# Groundwater Application Review Summary Form

Application # G- 19257

GW Reviewer Mitra Khadka/Travis Brown Date Review Completed: 05/05/2023

TO: Water Rights Section Date 05/05/2023  
 FROM: Groundwater Section Mitra Khadka/Travis Brown  
 Reviewer's Name  
 SUBJECT: Application G- 19257 Supersedes review of \_\_\_\_\_  
 Date of Review(s)

Water-Level Measurements in Nearby Wells

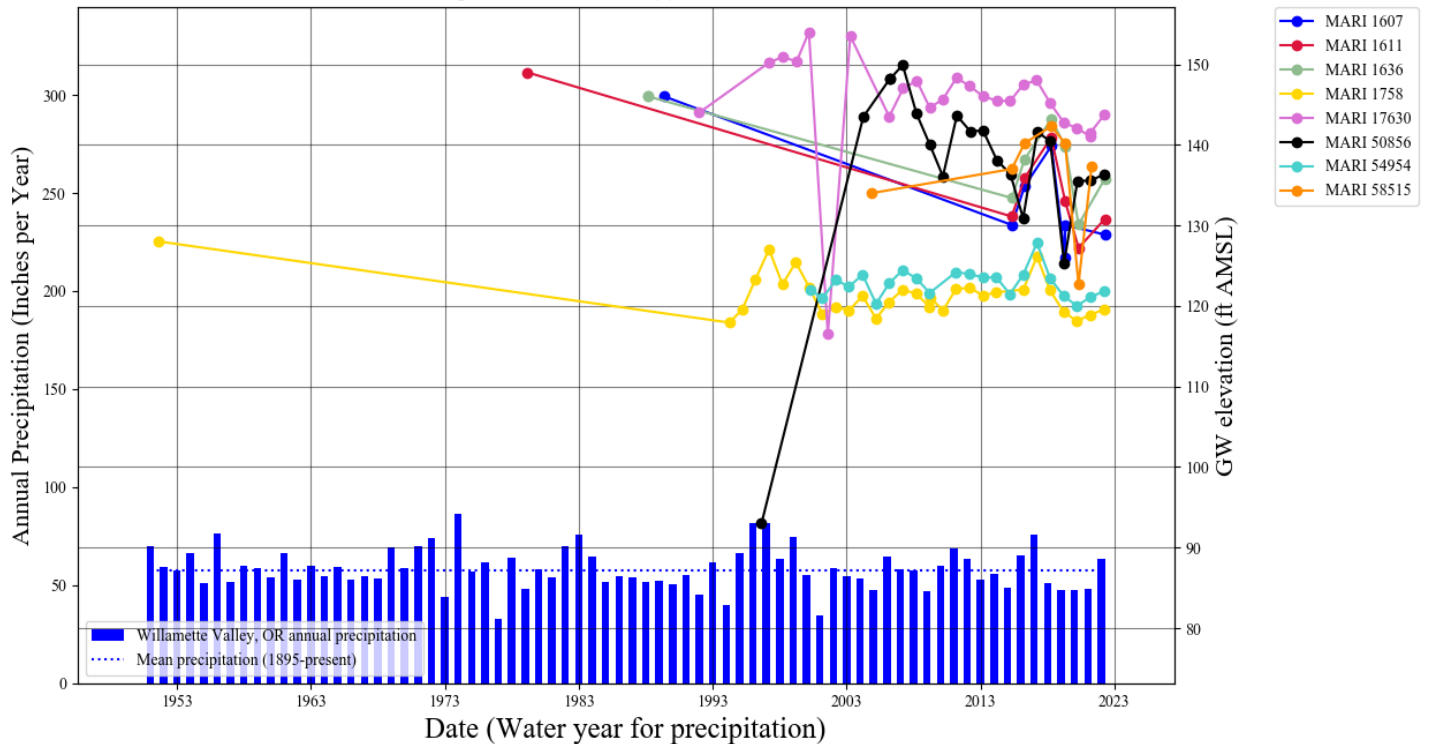
Hydrographs from the nearby wells (MARI 1607, MARI 1611, MARI 1636, MARI 17630, MARI 50856, MARI 58515) indicate annual high groundwater level decline over the years, with some periods of groundwater level recovery that correspond to above average annual precipitation (see attached Hydrograph). In some case, declines are greater than 20 ft from the highest know groundwater levels (e.g., MARI 1611). However, declining groundwater level trends do not meet the definition of declined excessively or excessively declining per OAR 690-008-0001. Completed depths of those wells range from 213 to 315 ft bls and the wells most likely produce from the Willamette Confining Unit. Two other wells (MARI 1758 and MARI 54954), located about 1.5 mile southeast of proposed POA locations show relatively stable annual high groundwater levels for the last 20-25 years. Those wells were completed to the depth of 145 ft and 179 ft bls, respectively and most likely produce from the same aquifer as proposed POAs.

**Well Interference Analysis**

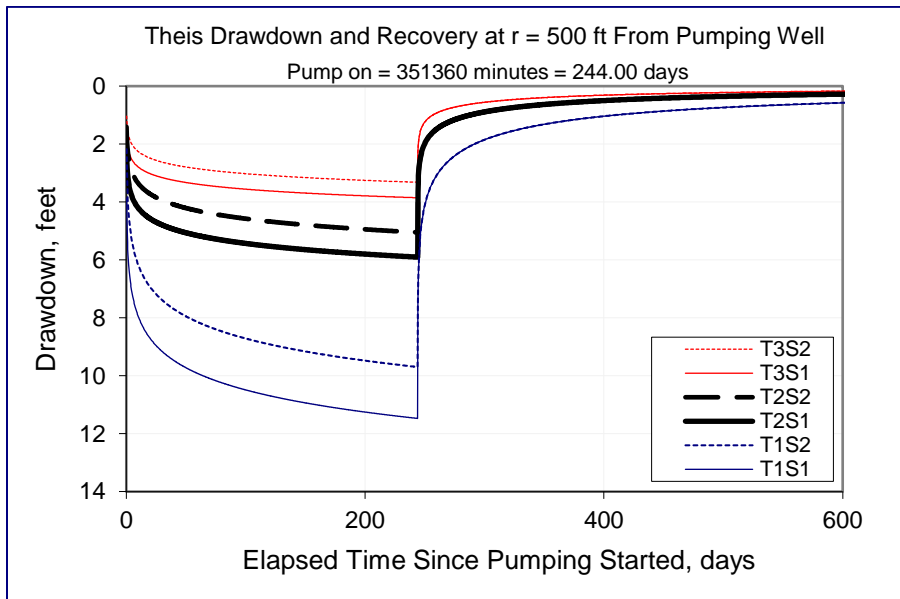
The nearest permitted well (MARI 1716) is located about 500 ft south of the proposed POAs. Interference with MARI 1716 was quantitatively estimated using a Theis (1935) time-drawdown model for a confined aquifer. Hydraulic parameters used

for the analysis were derived from regional data and studies (Pumping Test Reports; Conlon et al., 2005; McFarland and Morgan, 1996). The analysis estimates maximum drawdown to be ~12 ft in MARI 1716 after 244 days of continuous pumping at the maximum requested rate (see attached Well to Well Interference). The proposed use of groundwater is not anticipated to cause Substantial and Undue Interference with neighboring wells that meets a definition of well-to-well injury.

The available hydrogeological and groundwater levels data indicate that the proposed groundwater reservoir is not over-appropriated and is within the capacity of resources in the area. However, in order to monitor and protect the resources and other groundwater rights in the area, the conditions specified in Item B1(d) and B2(c) are recommended for any permit issued pursuant to this application.
